#### Addendum #3

# RFP 20-044 GATEWAY GREEN LIGHT (GGL) PHASE 6 – PE PACKAGE C IMPLEMENTATION OF EMERGENCY VEHICLE PREEMTION CMAQ-5414(634)

# Pre - Proposal Meeting Q and A

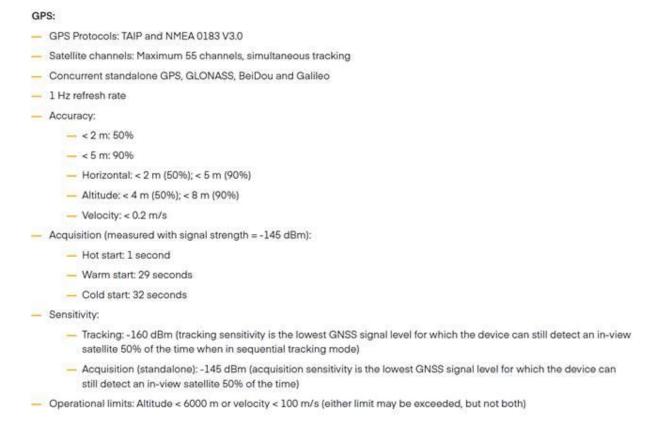
Question on Section 5.2 Vehicle Interface section 6: Could you please clarify "The Vehicle shall provide GPS geo-locating with the following data requirements:"

- 1. Is this data already available from the County's current "Central Square" module(s), or is the successful bidder expected to provide additional hardware to provide this data?
- 2. If "Central Square" modules currently installed on the vehicles are already providing this information, and there is an update rate: <1 sec, could you provide us the transmit rate to us?

- 1. It is capable of sending location data however the previous vendor solution we reviewed required specifics that were not realistic with the equipment we had and therefore we elected to use vendor provided equipment and only use our modems for a data connection point to allow their device to access communicate using our router's broadband connection.

- 2. After reviewing the settings on the IBR900 GPS is in seconds not milliseconds, that said if it will accept 0.25, we would have to test the concept... I don't believe it works if I recall. I reviewed the specs manual and did not find these details. I will look for other documentation for this model. I attempted to connect to the TSS Cradlepoint via Netcloud and it appears the TSS test router has been reset or the or the remote connect password has change. I confirmed in our Level I passwords the device connection admin password but that failed. I did confirm the variant we ordered in the past was IBR900-1200M-B this according to the spec sheet is FirstNET ready and includes support for band 14.

## GPS information available below:
